R08NC

**SUBJECT: RECALL R08NC FMVSS 221 SCHOOL BUS BODY JOINT
STRENGTH NONCOMPLIANCE-INCORRECT
RIVET PATTERN IN REAR ROOF CAP**

Rear Roof Cap Rivets

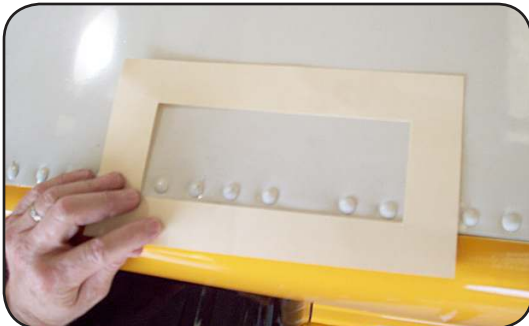
On some units, the rivet spacing may be incorrect in some segments of the rear roof sheet and rear roof cap joint, resulting in noncompliance with FMVSS 221, School Bus Body Joint Strength.

2 Inspect rivet spacing at rear roof sheet and rear roof cap joint. Joint must have a minimum of six rivets in an eight inch segment.

2.1 Place the template over the joint and parallel to the edge of the roof sheet, allowing roof rivets to be exposed through the opening in the template as shown.

2.3 If a segment in the rear roof cap joint contains less than six rivets, additional rivets are required. Mark each area that requires additional rivets.

2.4 If one rivet is required; add a rivet equally spaced between the two rivets with the largest space in this section.

2.5 If additional rivets are required; add additional rivets between the largest spaces until a minimum of six (6) rivets have been added in the eight (8) inch segment.

3 Install rivet/s at each mark. Using a short 17/64" drill bit, drill a hole through the roof cap, roof sheet, and rear bow flange. Be sure to drill hole on a common centerline with existing rivets.
